# PARTS & SERVICE NEWS

REF NO. AA03111

**SUBJECT:** TRANSMISSION PUMP REPLACEMENT

**APPLICATION:** Komatsu Mechanical Drive Dump Trucks:  
530M: A30001 - A30038, 32628;  
HD1500-5: A30039 and Up

FIGURE 1. PUMP (PC0773)

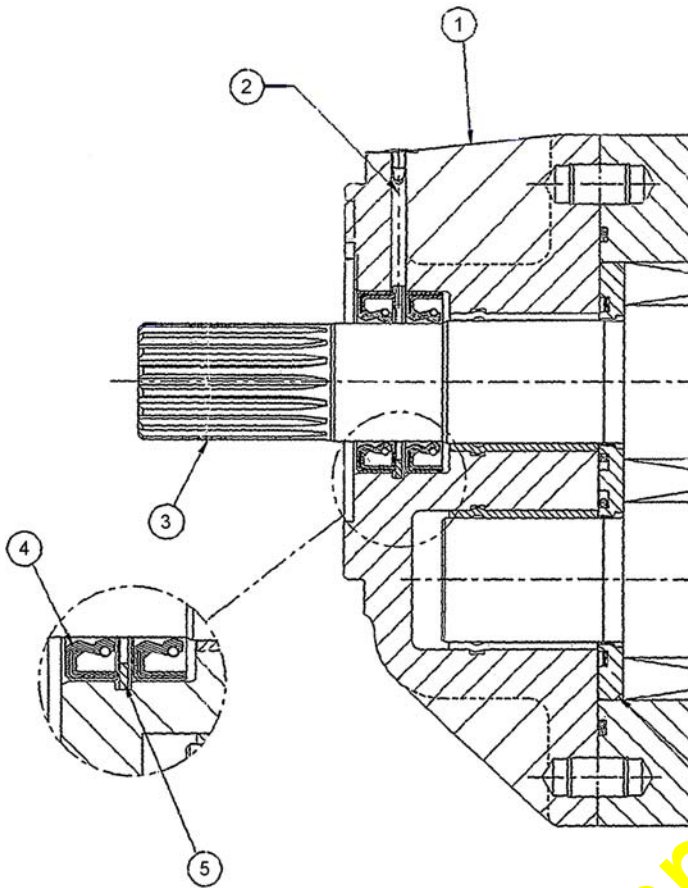
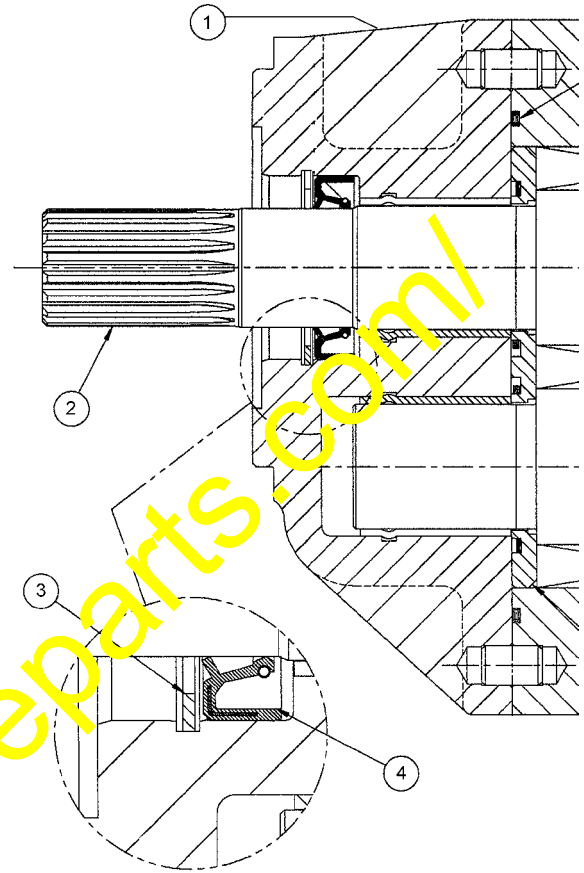
**DESCRIPTION:** New pump design due to shaft seal leakage through weep hole

Some transmission pumps may experience shaft seal leakage which will result in oil leaking through the weep hole and air entering the pump through the leaking shaft seal. A new pump (PC1577) has been designed to replace pump (PC0773) on a fix-as-fail basis.

The new transmission pump (PC1577) is directly interchangeable with pump (PC0773). The two "single lip" shaft seals (4, Figure 1) used in the older pump have been replaced with a single "double lip" shaft seal (4, Figure 2). The weep hole in the mounting flange has either not been machined or has been permanently plugged in the new pump.
